RFP Title: Park Improvements at General Street Park

Addendum #: 1

The purpose of this addendum is to publish revisions made to construction documents(L-5,L9).

9 OF 13

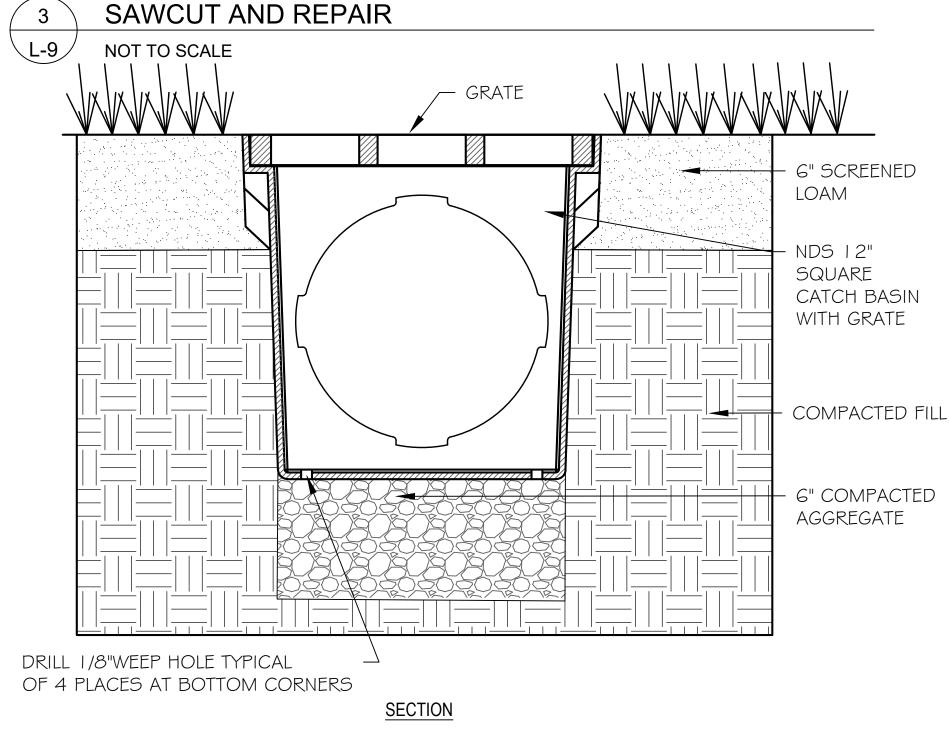
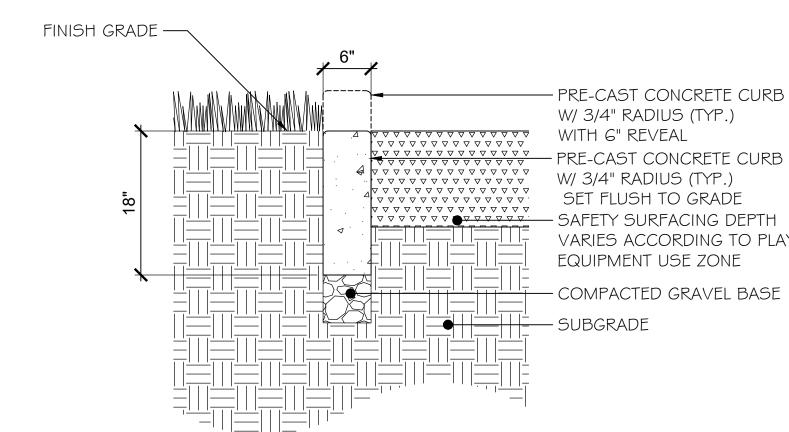
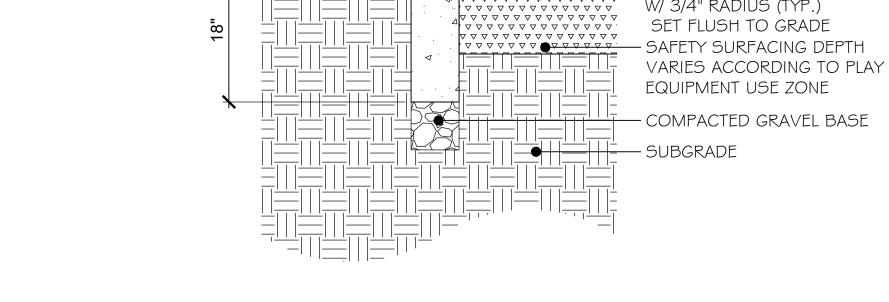
- 1. Addendum Cover Sheet (1page)
- 2. Pre-Bid Meeting Minutes (1 page)
- 3. Sign-in Sheet (1 page)
- 4. Revised Construction Documents (2 pages)
 - 1. L-5 Grading Plan
 - 2. L-9 Detail Sheet
